1022 Meredith Avenue - Preliminary
9/26/90 SUBDIVISION + Consultation

Re: Preliminary Consultation on Lots 10 and 11
Meredith Avenue, Silver Spring

SUBJECT: Review of Subdivision Plans

Preliminary Plan 1-89263
NAME OF PLAN: CAPITOL VIEW PARK

PRELIMINARY PLAN OF SUBDIVISION
 LOTS 10 & 11 BLOCK 7
 CAPITOL VIEW PARK
 Wheaton Election District
 Montgomery County, Maryland

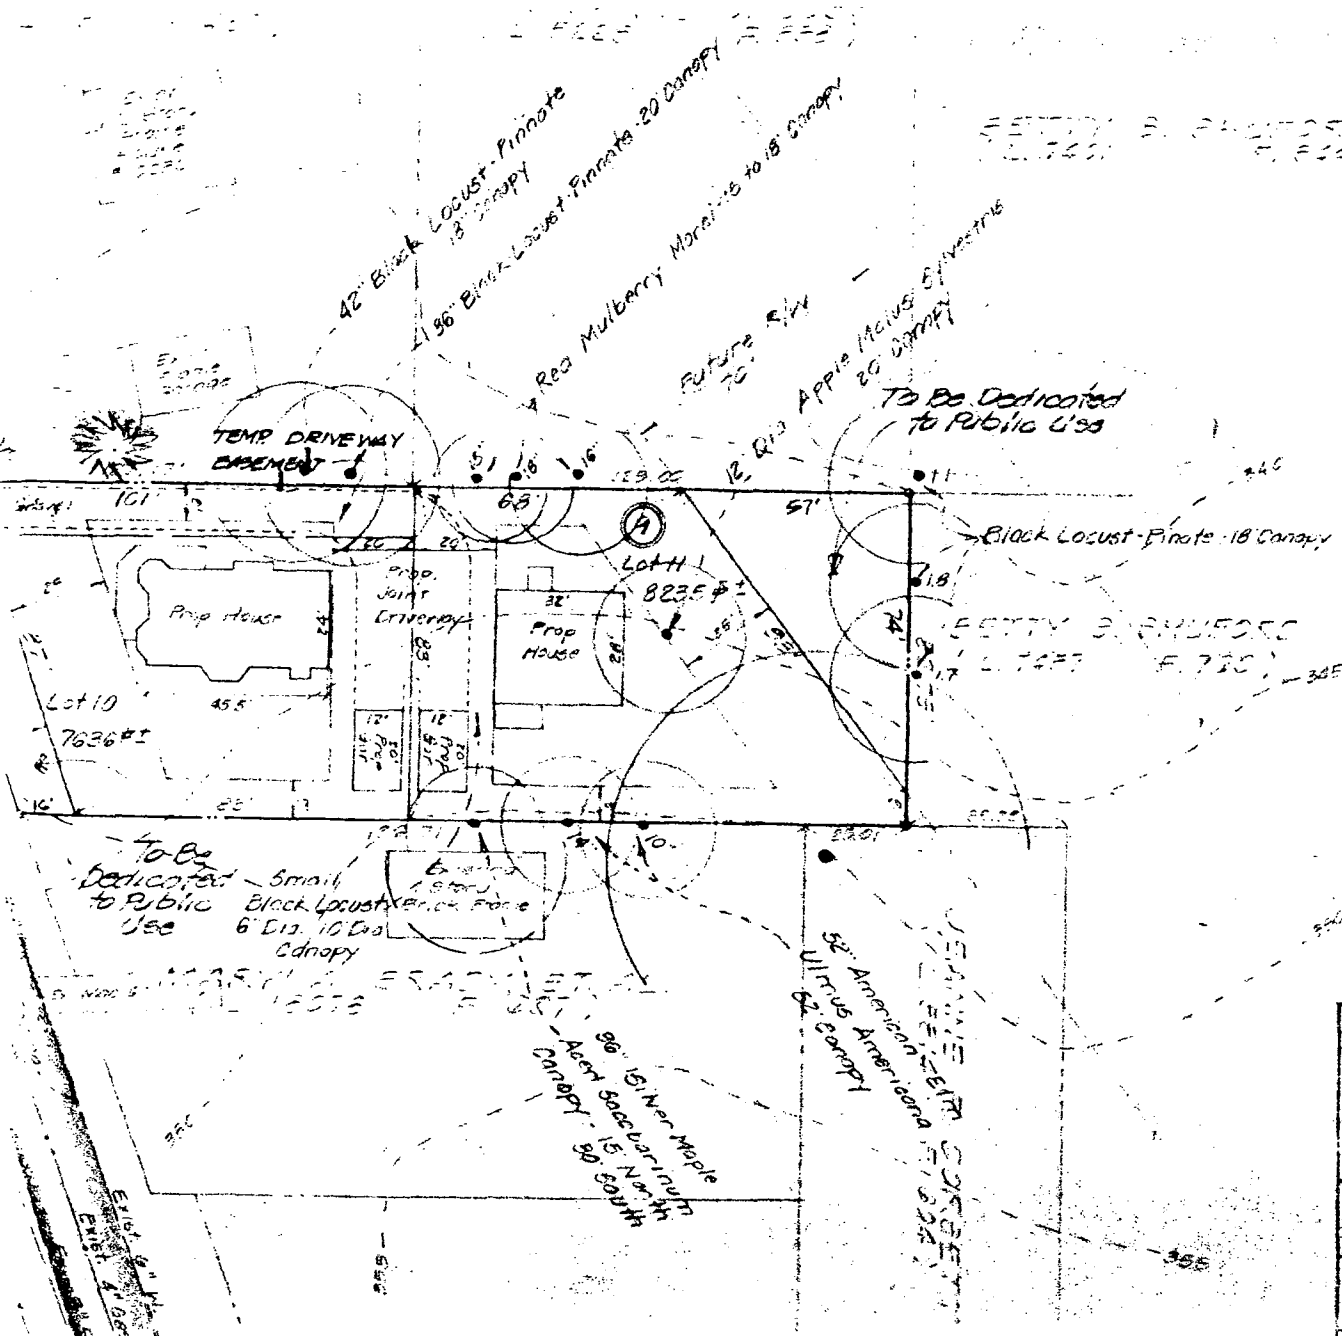
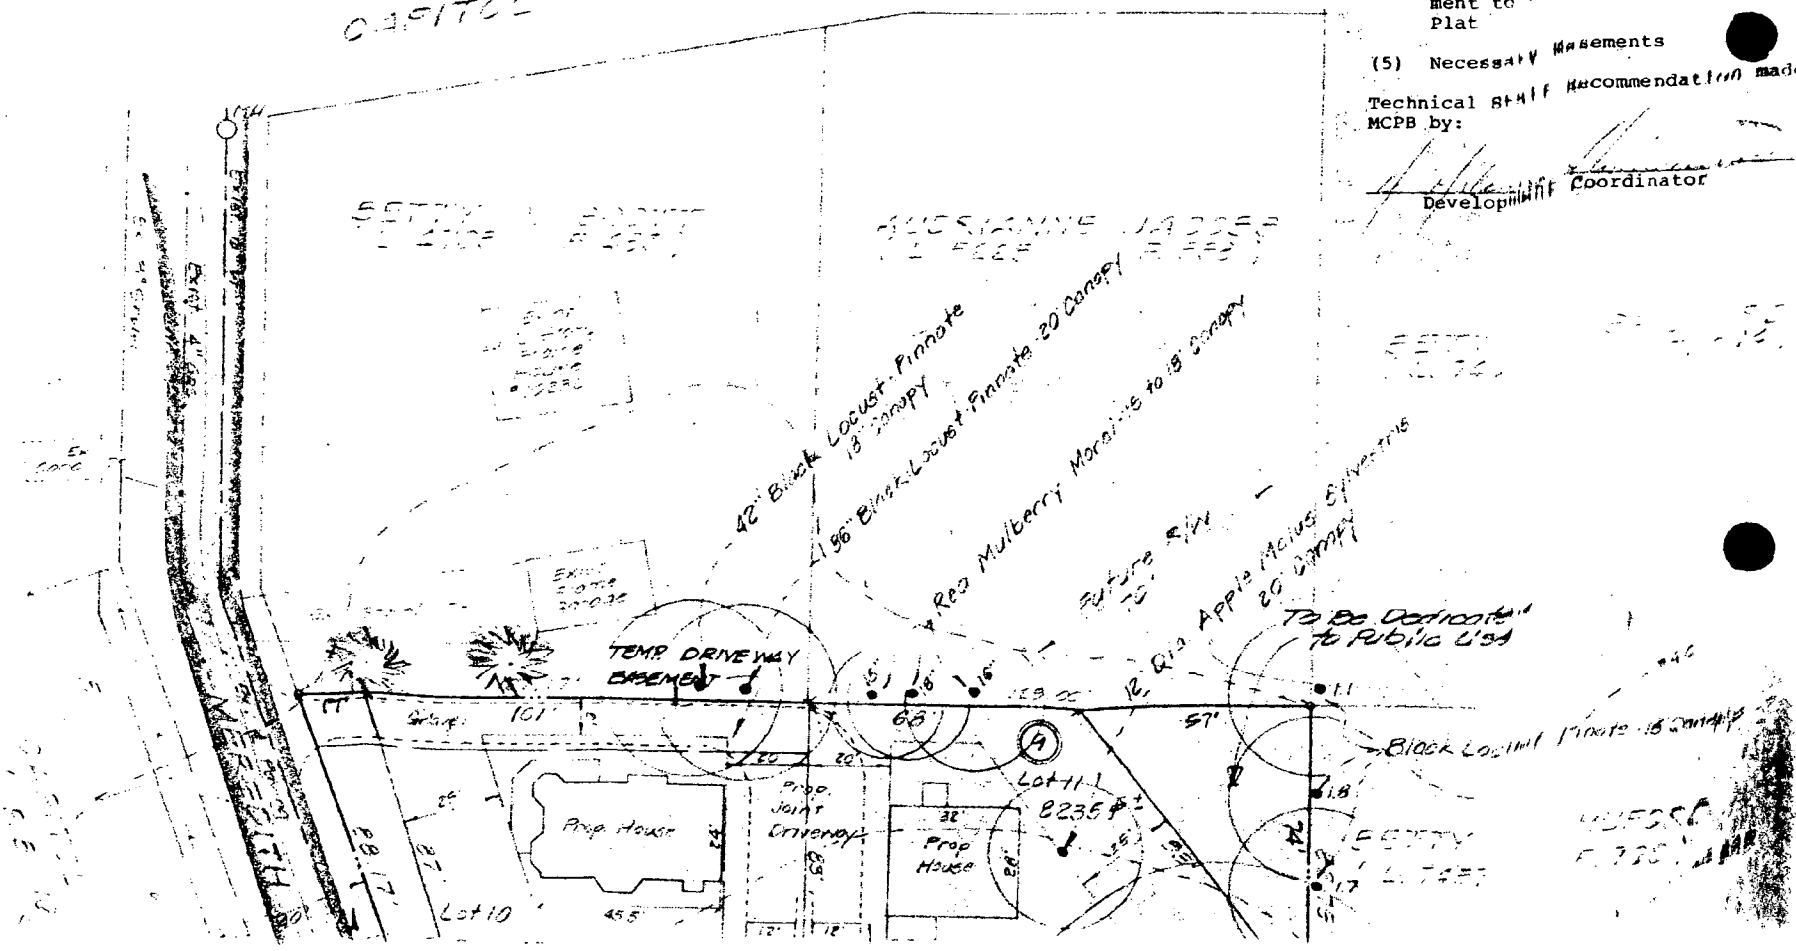
*DOES STAFF RECOMMEND
SOME FENCING INSTALLED AT
PROPERTY W/ FIELD INSPECTION
OR IS AN ARBORIST PLAN
ADDITIONAL OF NECESSARY?
GRAVEL DRIVE AS SHOWN
ACCEPTABLE AS PERMISSIBLE
SCALE FOR NORTH LINE
TREES?*

- (2) Revised ... must submit a report ... by a qualified ... provides details ... adjacent to north ... lines will be ... report is to be ... approved by MNCPPC ... staff. A ... must inspect ... and protection dev ... prior to ... and grading ... on all plans.
- (3) DEP Stormwater Management Waiver Dated 11-11-89
- (4) Common Utilities and Egress Easement to be labeled on Record Plat
- (5) Necessary Measurements
